STAFF REPORT

(Final Plat, Preliminary Plat Approved 11/21/96)

**CASE NUMBER:** S/D 96-83 - AUBURN HILLS 3RD ADDITION

**STAFF REPORT**  
(Revised One-Step Preliminary-Final Plat)

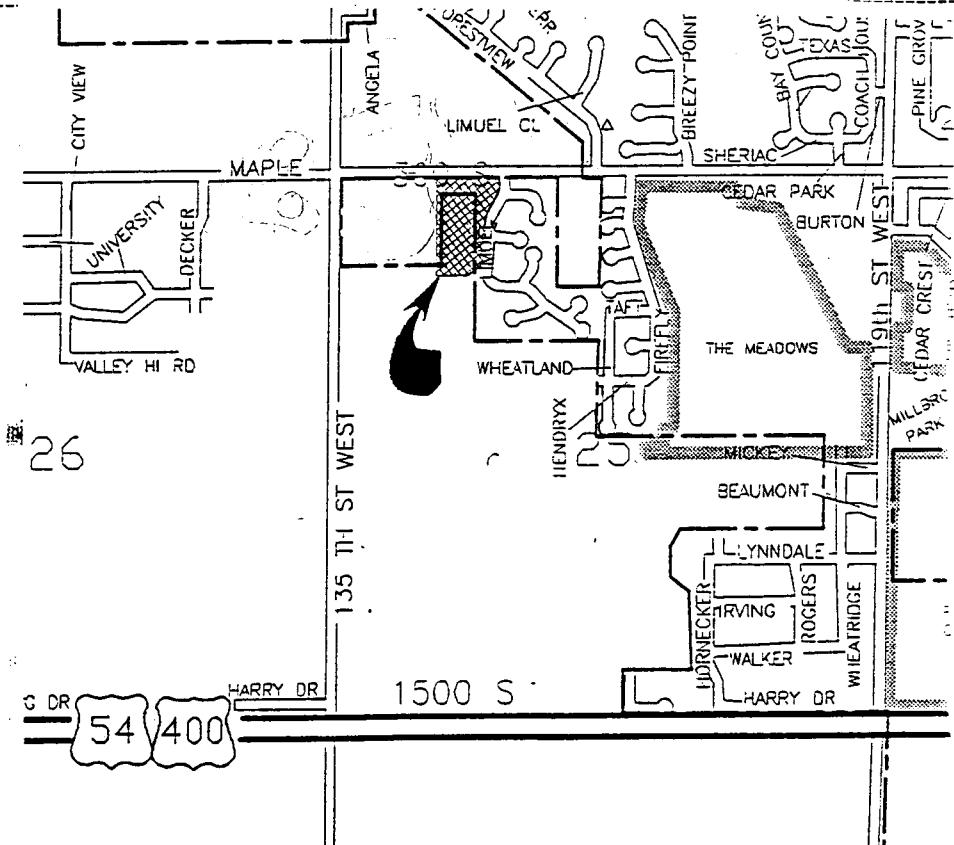
*Issue with utilizing  
County Sewer*

- H. On the final plat tracing, **complete access control** shall be shown to Maple from all abutting lots.
- I. The final plat tracing shall state in the plattor's text the purposes of the proposed reserves as well as who is to own and maintain the reserves.

- R. The final plat tracing shall indicate the utility easements requested by K.G. & E. which are indicated on the enclosed "marked" copy of the plat. Three (3) easements were requested during review of the preliminary plat but were not shown on this final plat.

- S. On the Final Plat Tracing, right-of-way for Maple shall be provided for 50-feet of 1/2 street right-of-way from this site. It appears that the 40-feet shown is not accurate and that 50-feet is the actual dimension. In any case, 50-feet shall be dedicated and properly shown.

- T. On the final plat tracing, the center line ("CL") of Maple shall be labeled.
- U. On the final plat tracing, the following amendments shall be made to the plattor's text.

5. Both the face of the plat and plattor's text has deleted reference to a wall easement along the site's north line. If a wall is still intended, both the face of the plat and plattor's text will need to indicate this. In regard to the 20-foot easement now being shown, any 5-foot wall easement would need to be platted exclusive of any other such easements (utility, drainage, etc.). That is a 20-foot utility/drainage easement, with an

- W. City Engineering needs to indicate the acceptability of the joint utility and drainage easements being shown on this plat. While such joint easements are a requirement adjacent to narrow, 32-foot right-of-way streets such as Kent/Mentor, they are not typical for other locations.

- X. The applicant was requested to discuss this plat's street names with various City staff. The applicant and Fire Department representative need to indicate if the revised street names were determined as being acceptable and are acceptable as now being shown on this plat. In regard to W. Kent, the prefix "W" would not appear to be appropriate. Kent exists to the east of this site (1/2 mile) but is only found in this area. That is, there is no "E" side Kent and the use of "W" Kent may imply a new, different Street.

The "eyebrow" court coming off of Kent as shown is not a circle, and if distinctly named, should be labeled as a Court (a Kent Ct.)

For Kent, additional street right-of-way dimensions need to be shown for this street's entrance from Limuel and for the Court area that surrounds Reserve "D". If necessary, separate distinct drawings of these areas may need to be added to the final plat tracing.

- CC. On the final plat tracing, the indicated tiepoint to the N.E. corner of the N.W. 1/4 (quarter) needs to reference range 2W not 2E.
- DD. Also, the tying of this site to a Reserve in the Auburn Hills (1st) Addition, at the northeast corner of this plat, should correct the involved Reserve as being Reserve "A" not "F".
- EE. On the final plat tracing, appropriate dimensions shall be shown for the building setbacks of corner lots. Specifically, Lots 20 and 25, Block 1, shall indicate a 15-foot building setback to Limuel. Lot 1, Block 2 also needs to indicate additional dimensions to better describe the setback being shown to Limuel.
- FF. Before this plat can be released for recording, proof shall be provided that all applicable property

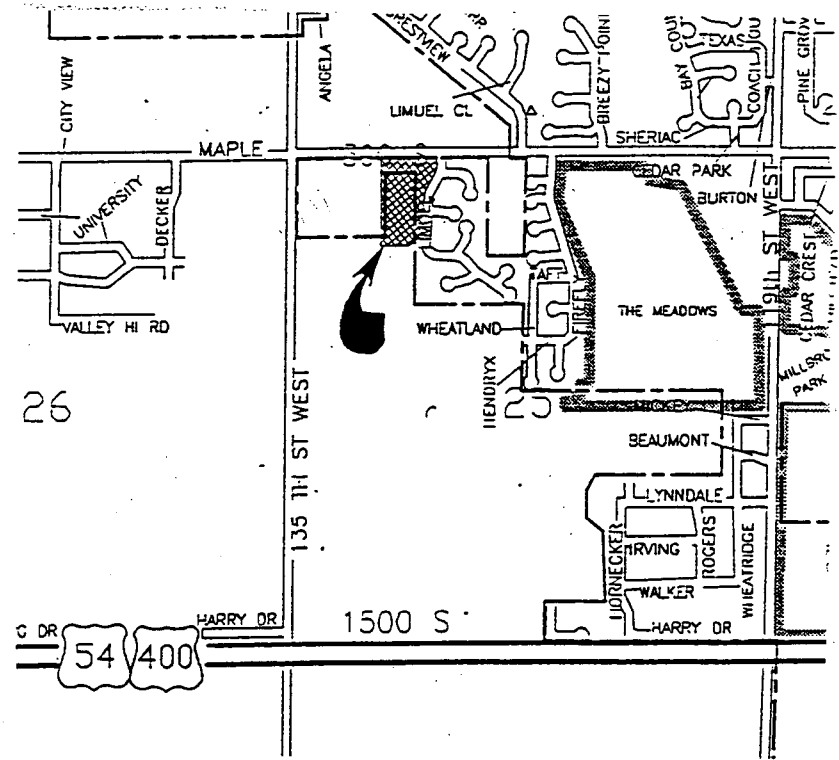
- D. The applicant shall guarantee the paving of the proposed interior streets. Traffic Engineering needs to comment on the need, if any, for improvements to Maple Street or Limuel Street.

- E. Sidewalks should be provided along the east side of Limuel.
- F. The applicant shall guarantee the construction of any drainage improvements required by the platting of this property, including storm sewers.

- H. A covenant providing for 4 off-street parking spaces per dwelling unit shall be provided as required when the 58 foot local residential street standard is being used. The covenant shall inventory the affected lots by lot and block number and shall state that the covenant runs with the land and is binding on future owners and assigns.

- I. On the tracing, the platter's text should note the platting of the wall easements and that utilities may cross such wall easements.
- J. Representatives from the **City Fire Department** and / or OCI need to comment of the acceptability of proposed street names.

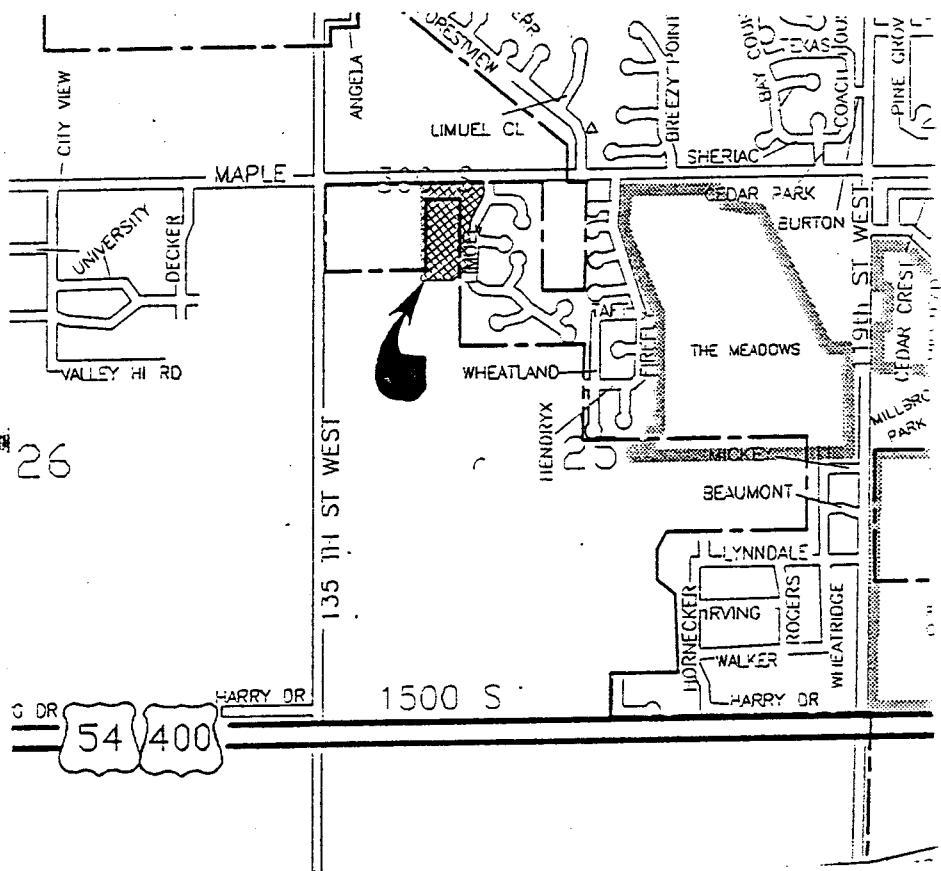
*Drainage*

- D. The applicant shall guarantee the paving of the proposed interior streets. Although the sidewalk ordinance does not require it, it is recommended that the paving petition include sidewalk along one side of Limuel Lane so as to connect with the sidewalks along Limuel as provided with the first Auburn Hills Addition.

- H. As required of streets being platted with 32-foot rights-of-way, 15-foot street-drainage-utility easements should also be platted along all adjacent lots and Reserves.

- I. On the final plat, complete access control shall be shown to Maple from all abutting lots.
- J. On the final plat, the plattor's text shall note the platting of the wall easements and that utilities may cross such wall easements.

- P. On the final plat, Lot 3 can be replatted with a continuation of lots platted as Block 1, i.e., Lots 20-25 of Block 1, rather than Lots 1-6 of a Block 3. These lots are continuous and need not be shown by separate blocks.

- Q. The representative from the City's Fire Department and/or OCI need to indicate the acceptability of this plat's use of the street name Limuel as a "Lane", "Court", and "Circle".
